Lincolnshire and Northamptonshire Breach Hazard mapping

From: Eames, Rob <Rob.Eames@environment-agency.gov.uk>
Sent: 12 November 2018 18:16
To: Burton, Helen
Cc: Kearns, Laura; Farr, Nicola; Cobb, Kirsty
Subject: RE: Proposed Energy Centre Development at South Humber Bank Power Station

**Request for Scoping Opinion - construction and operation of an energy from waste power station with a maximum gross electrical output of 49.9 MW
South Humber Bank Power Station, South Marsh Road, Stallingborough, Grimsby**

RE: Application Number: DM/0575/18/SCO - South Humber Bank Power Station South Marsh Road
Stallingborough Grimsby North East Lincolnshire DN41 8BZ

Lincolnshire and Northamptonshire Breach Hazard mapping

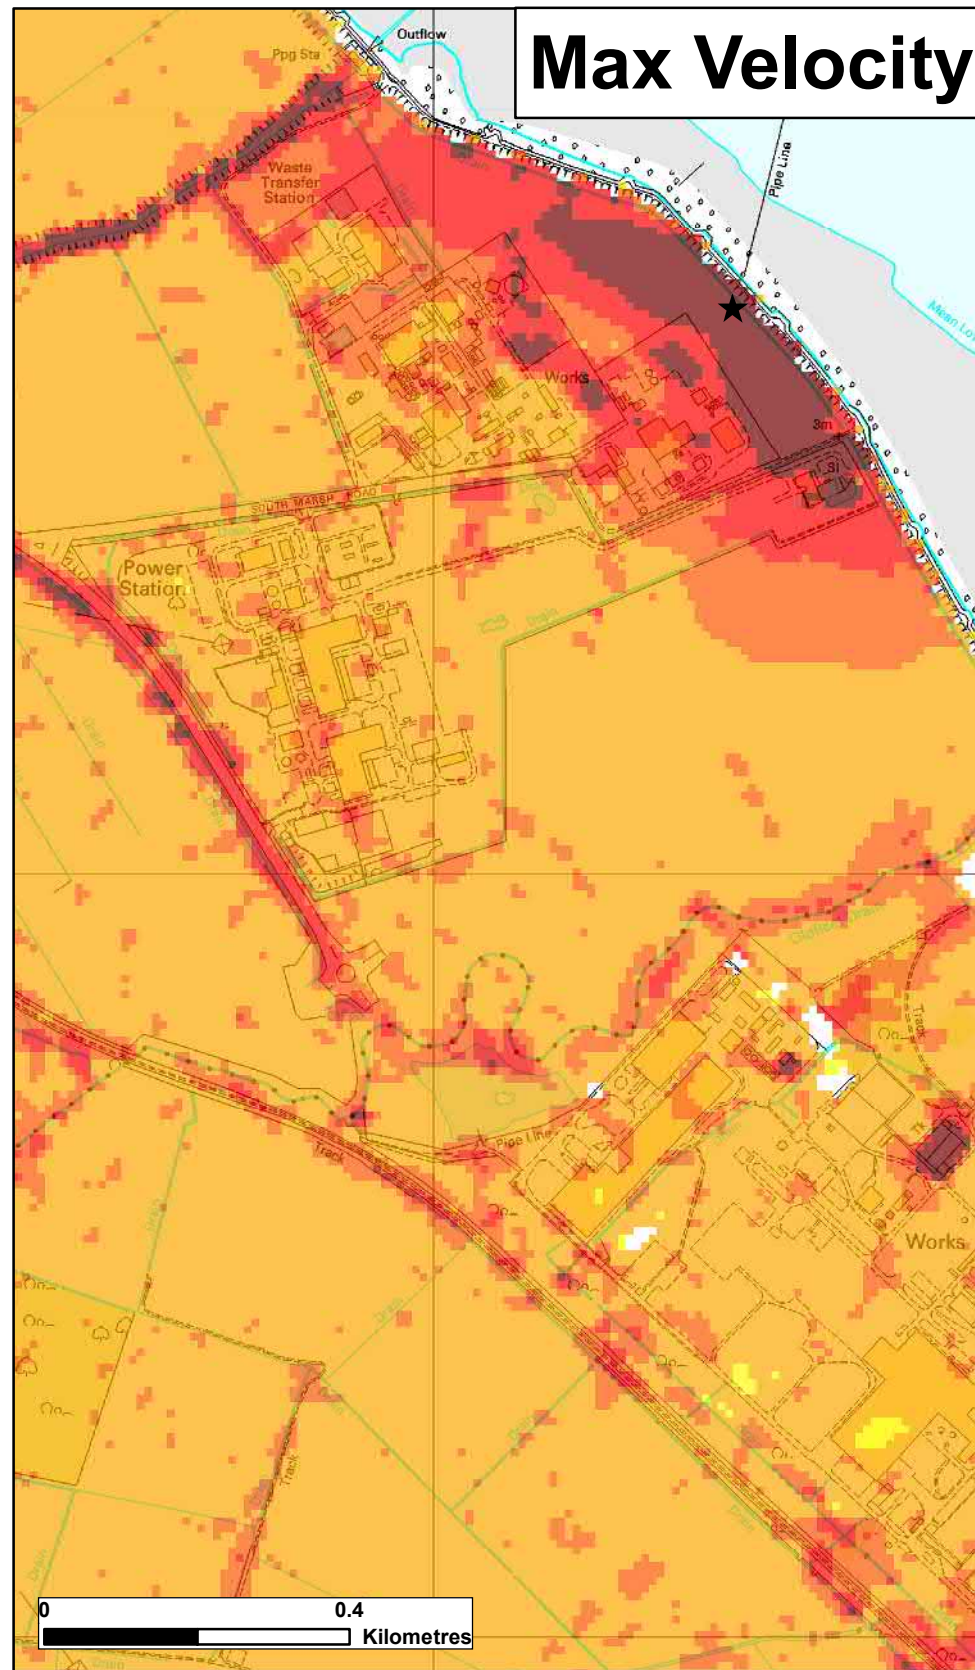
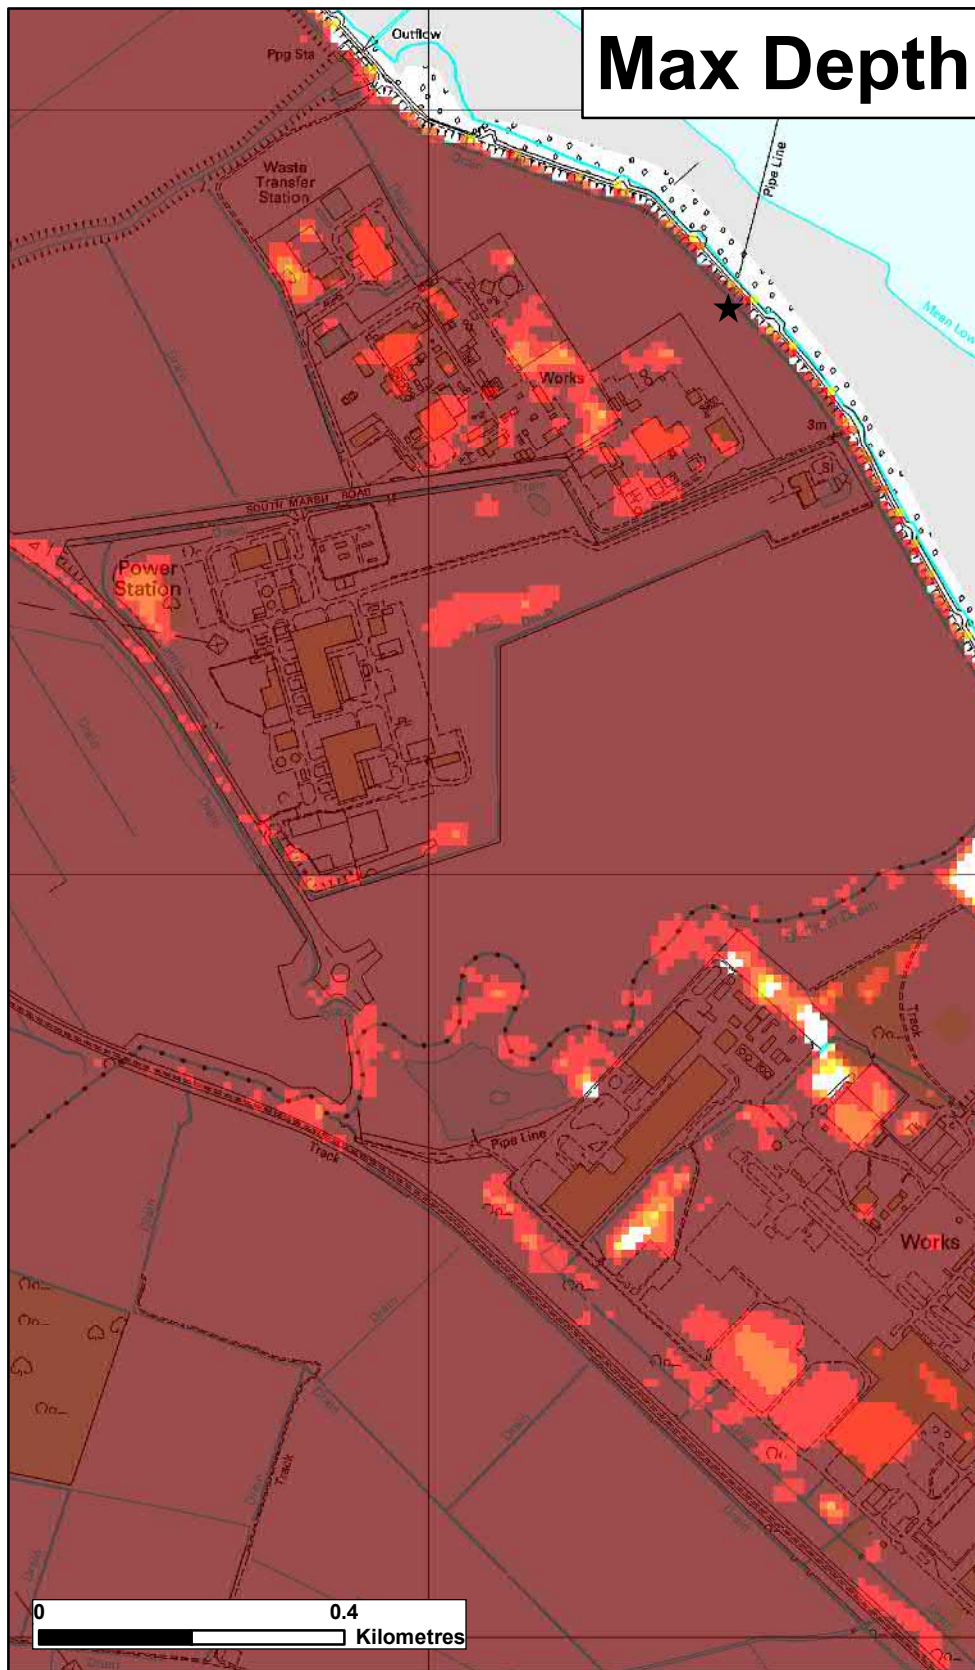
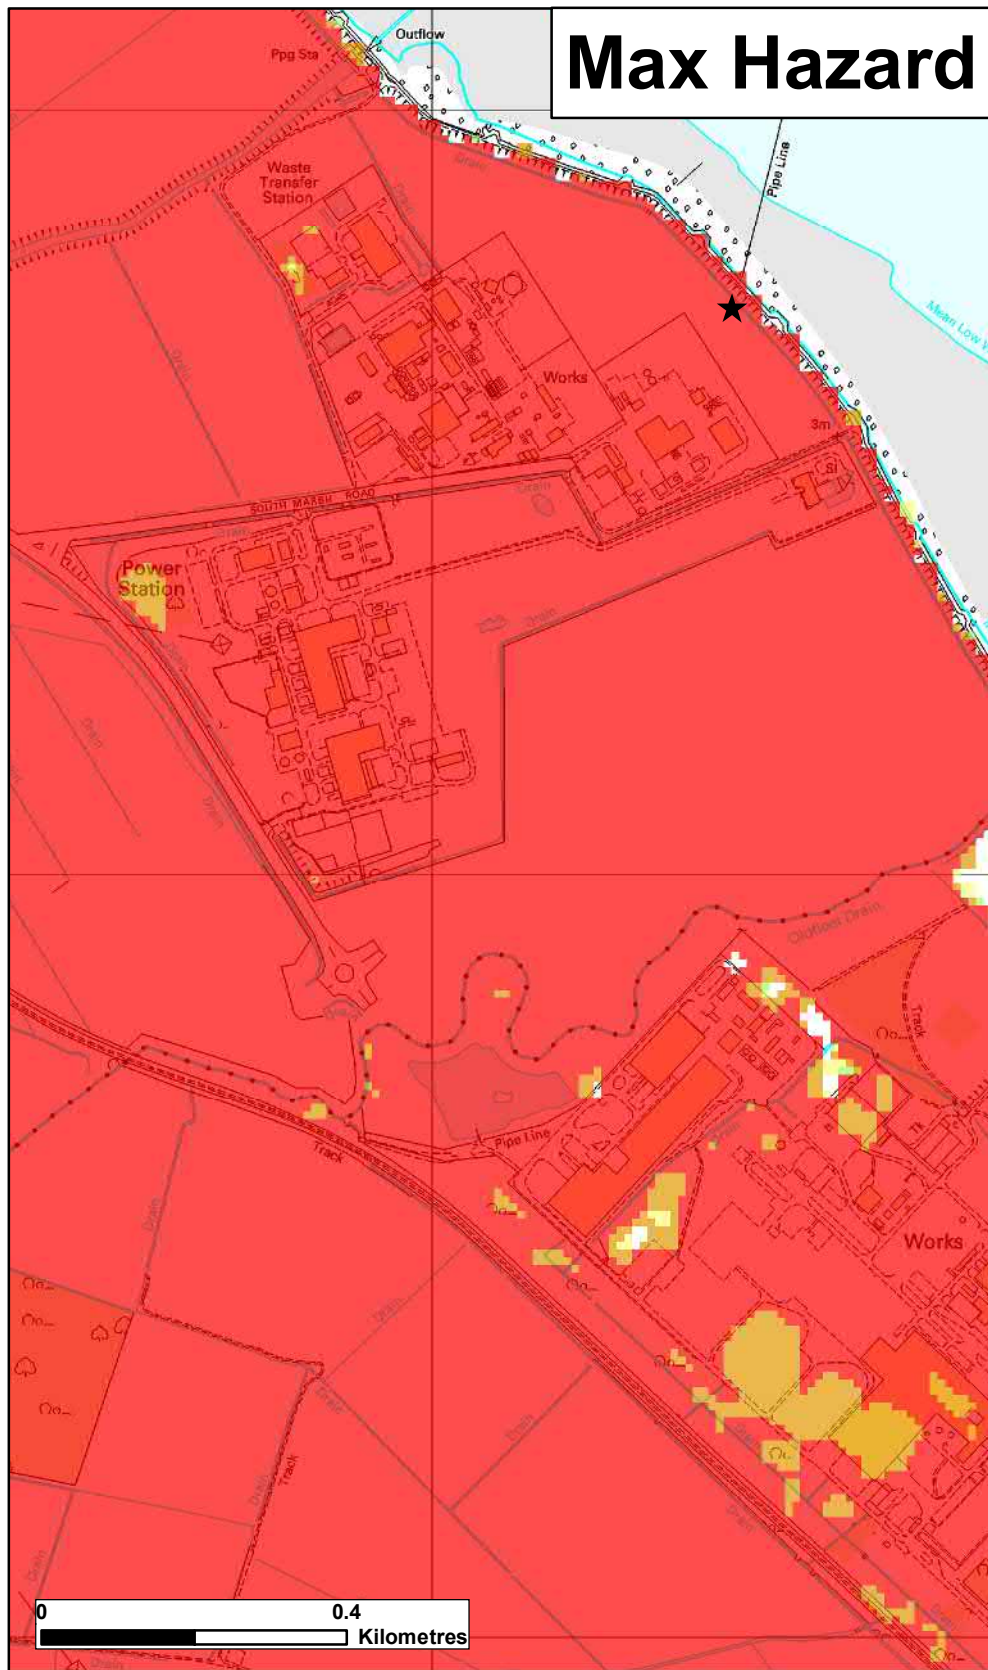
Many thanks for providing the additional information and maps below. The difficulty with providing only depth bands in meters (m) is that if we apply those above varying LiDAR ground levels (GL), we cannot accurately define a consistent minimum level in meters Above Ordnance Datum (mAOD) above which the critical equipment and designated place of refuge at the site should be elevated to be considered safe in the unlikely event of a defence breach.

For example, see data for the 5 locations highlighted below. If I compare the EA 1m LiDAR against the 0.1% AEP to 2115 depth bands provided, this results in a large range in potential water levels (WL) (approx. 800 mm). I understand that the peak water level may vary slightly across a large area where the land exhibits a gradient, but the wider area is relatively flat so we would not expect such a large variance in ponded WLs behind defences. Even if we include a freeboard to account for the uncertainty (usually up to 300 mm requested by the EA), it leaves it widely open to interpretation as to which value to choose to apply that to, and being overly conservative may significantly increase costs to the developer.

It is my understanding that any hydraulic model that produces an ASCII grid of depth results across the flood extent should also produce an ASCII grid of coincident WL/stage results in mAOD units, as it is from that which the model calculated the depths from above the ground terrain model that was used in the model geometry. If the EA do possess the breach model output ASCII grids with mAOD units, would it be possible for these to be provided across the site and local vicinity either in ASCII format via your 'Sharefile' facility, or in a plan illustrating the WLs in a grid of spot points across the site? From this we are intending to identify the highest WL in the areas proposed for development above which to recommend the equipment/safe place of refuge are elevated above. We usually receive this sort of information from other EA areas as part of a Product 6/8 data request.

If it is not possible to provide this, would the EA be able to recommend how we reconcile the large margin of potential inaccuracy incurred from the depth bands in relation to the widely varying GLs in the site boundary (1.9 to 3.7 mAOD) to determine the necessary recommendation?

As the modelling shows that the depths are significantly greater than the 1.6m (+) maximum banding I have attached two breach depth maps – one for the 2115 0.5% (1 in 200) scenario and one for the 2115 0.1% (1 in 1000) scenario. I have reduced the bandings to 250mm and increased the number for the upper depths to cover the depths we discussed. I can't give you a definitive answer for depth but the maps will give you an idea of what the modelling has highlighted.

Unfortunately I'm not able to easily give you depths in mAOD. The breach hazard mapping is created without specific land levels being referenced in mAOD as the accuracy of this information is subject to change. You can however reference against the latest LIDAR available [here](#).
